Colorado Smelter Superfund Site Pueblo, Colorado

Early Interim Action Residential Property Cleanups Operable Unit 1 – Community Properties Record of Decision September 2017

EARLY INTERIM ACTION RESIDENTIAL PROPERTY CLEANUPS OPERABLE UNIT 1 – COMMUNITY PROPERTIES

RECORD OF DECISION DECLARATION

Typical slag pile left in place in Leadville:

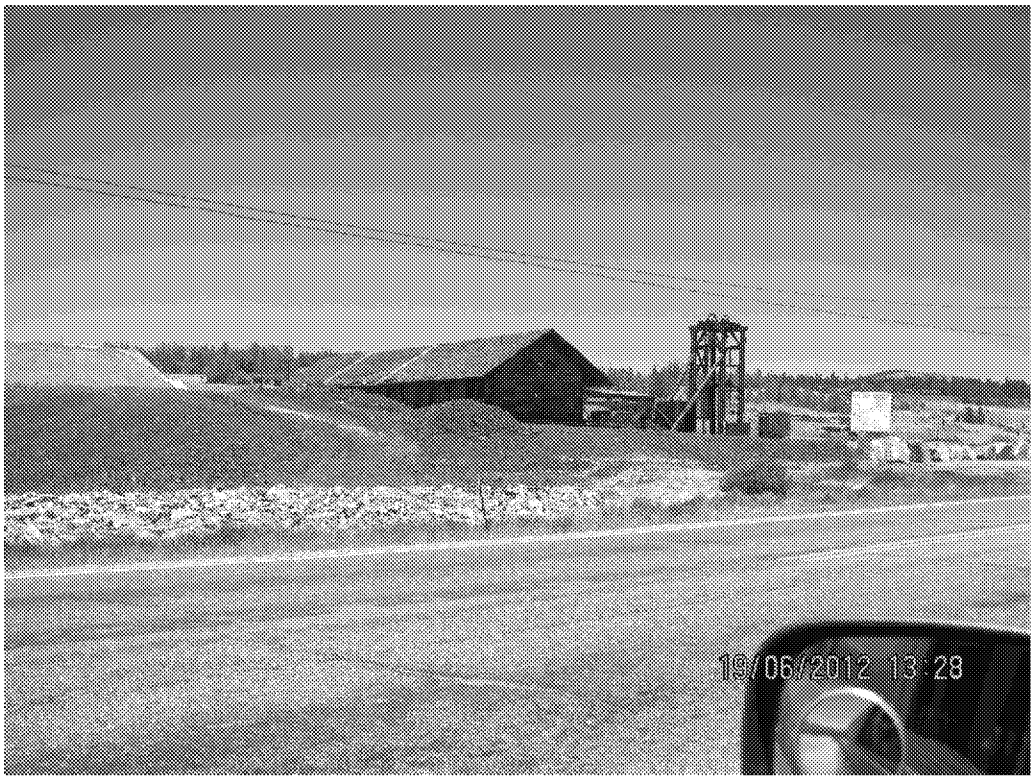
Note the homes in the lower right of this photo only the roofs are visible, but they are very close to the slag pile. This was not of apparent concern for EPA R8.
